FINAL
NAVAL AIR STATION ALAMEDA RESTORATION ADVISORY BOARD
MEETING SUMMARY

June 7, 2007

**Operable Unit 3
Installation Restoration Site 1
1943-1956 Disposal Area
Summary of Responses to Restoration Advisory Board
Comments on Proposed Plan
Alameda Point, Alameda**

RESPONSES TO PUBLIC COMMENTS ON THE FINAL PROPOSED PLAN FOR IR SITE 1, 1943-1956 DISPOSAL AREA, ALAMEDA POINT, ALAMEDA, CALIFORNIA

Golf Course

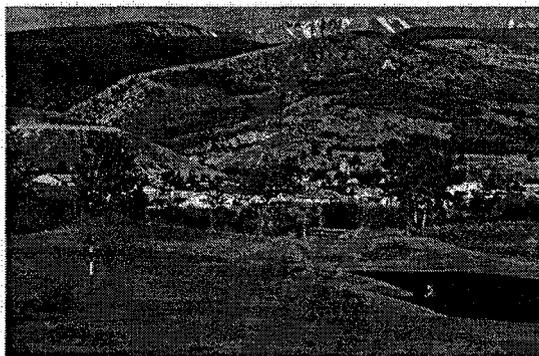
Comment 17 on page C-24 (Slide 19) said it was unclear whether the Navy has considered the re-use plan for a golf course in the RD. The Navy responded that it takes into account the future re-use of the site and has reviewed EPA's guidance document for reusing cleaned up Superfund sites and installing golf courses.

Comment 20 on page C-25 (Slide 19) asked about responsibility for maintaining the cap once a golf course is in place. The Navy responded that maintenance will be included with other ICs for the remedial actions and the Navy will seek to transfer this responsibility to the future land owner by contract, property transfer agreement, or other means. In any event, the Navy retains ultimate responsibility for the integrity of the remedy.

Comment 30 on page C-45 (Slide 19) stated that surface inspection of the runways, the proposed soil cap, or an engineered cap would not be possible once a golf course is built. The Navy responded that maintenance would occur only to exposed runways. EPA has issued an information document, "*Reusing Cleaned Up Superfund Sites: Golf Facilities Where Waste is Left on Site*," that provides examples of golf courses that were successfully constructed on landfills and that endorses future use of landfills as golf courses. Ms. Konrad asked about Navy plans if reuse is not a golf course. Mr. Macchiarella said there are multiple reuse scenarios that are satisfied in the current remedy and includes residential reuse restrictions. Ms. Konrad said that the city may be considering other uses. Mr. Macchiarella said that there may be certain restrictions in some areas and different restrictions in other areas. Restrictions on disturbing the cap will be in place for the landfill area. No major structures will be built over this area. No significant restrictions as Area 1A are envisioned for the remainder of the site. Mr. Coe asked if the Navy has studied possible compaction of the landfill and cap. Mr. Macchiarella replied that the ROD does not go into detail on this issue because it will be considered during the RD phase. Ms. Konrad asked about the size of Area 1A. Mr. Baughman replied 22 acres. Mr. Humphreys commented that part of the area is along the shoreline park where restrooms may be built. Mr. Macchiarella replied that restrictions probably would not be the same for this area as for the landfill. Ms. Konrad asked about covering the runway area. Mr. Baughman replied that the Navy plans to cover the entire Area 1A. Ms. Smith said there may be contamination under the runway. Mr. Baughman said that the runway is composed of several feet of concrete. Slide 20 showed the title page from the EPA document, "*Reusing Cleaned Up Superfund Sites: Golf Facilities Where Waste is Left on Site*."

Comment 30, pg C-45

- Surface inspection of the runways, or for that matter the proposed soil cap or engineered cap, would not be possible once a golf course is built
- Maintenance of the runways would only occur to exposed runways
- EPA has issued an information document entitled "Reusing Cleaned Up Superfund Sites: Golf Facilities Where Waste is Left on Site" that provides examples of installed golf courses successfully being constructed on landfills and that endorses future use of landfills as golf courses

- Unclear whether the Navy has considered the re-use plan for golf course in its remedial design
- The Navy does take into account future re-use of the site, and has reviewed EPA's guidance document for reusing cleaned up Superfund sites and installing golf facilities

Response
